OCONEE NUCLEAR STATION, UNIT NO.1

AMENDMENT TO FACILITY OPERATING LICENSE

Amendment No. 78 License No. DPR-38

SAFETY EVALUATION BY THE OFFICE OF NUCLEAR REACTOR REGULATION SUPPORTING AMENDMENT NO. 78 TO FACILITY OPERATING LICENSE NO. DPR-38

Figure 2.1 - 23

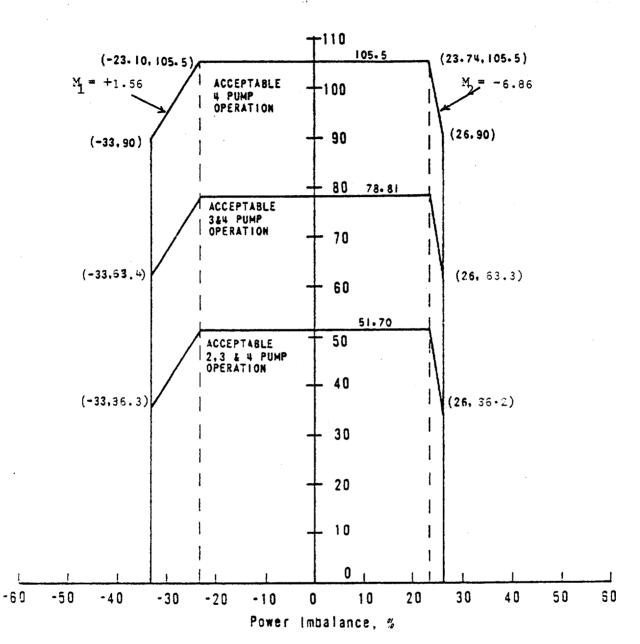
These amendments revise the core protection safety limits, protective system maximum allowable setpoints, control rod position limits, operational power imbalance envelope and axial power shaping rod position limits for Unit 2 consistent with extending the duration of the Unit's present operating cycle from 297 + 10 to 363 effective full power days. Editorial changes have been included as discussed and accepted by your staff.

The TS would be revised to establish new reactor protection system limits and set points to ensure operation of the core within the prescribed DNB and accident limits such as peak clad temperature. The TS curves (which are acceptable) were derived following the methodology of B&W Topical Report BAW-10121 entitled RPS Limits and Set Points, June 1978.

Figure 3.5.2-1B3

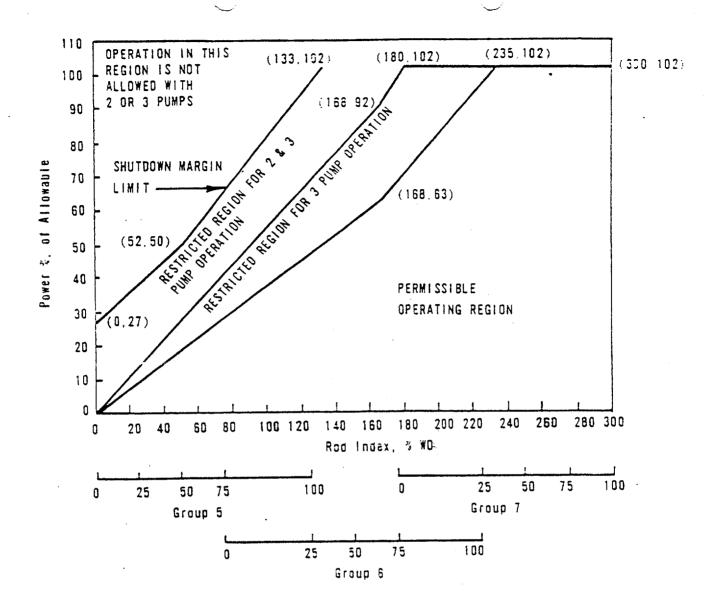
ROD POSITION LIMITS FOR FOUR PUMP OPERATION FROM 297 TO 363 EFPD UNIT 2 OCONEE NUCLEAR STATION

Figure 3.5.2-3B3

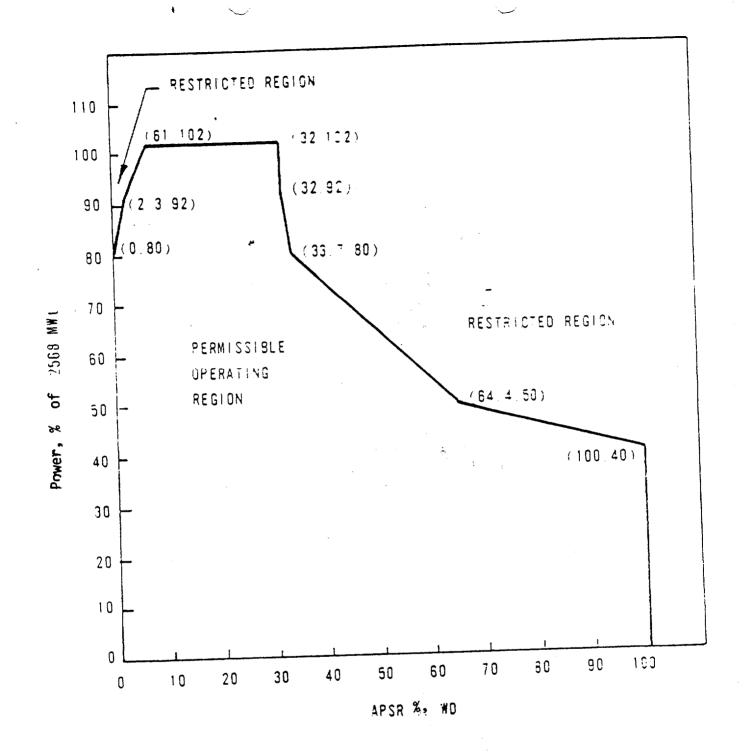
ENVELOPE FOR OPERATION FROM 297 TO 363 EFPD UNIT 2 OCONEE NUCLEAR STATION

Figure 3.5.2-4B3

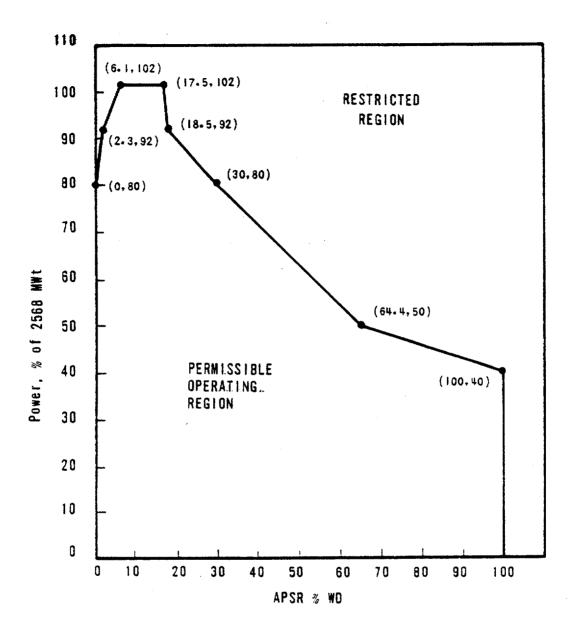
APSR POSITION LIMITS FOR OPERATION FROM 297 TO 363 EFPD UNIT 2 OCONEE NUCLEAR STATION
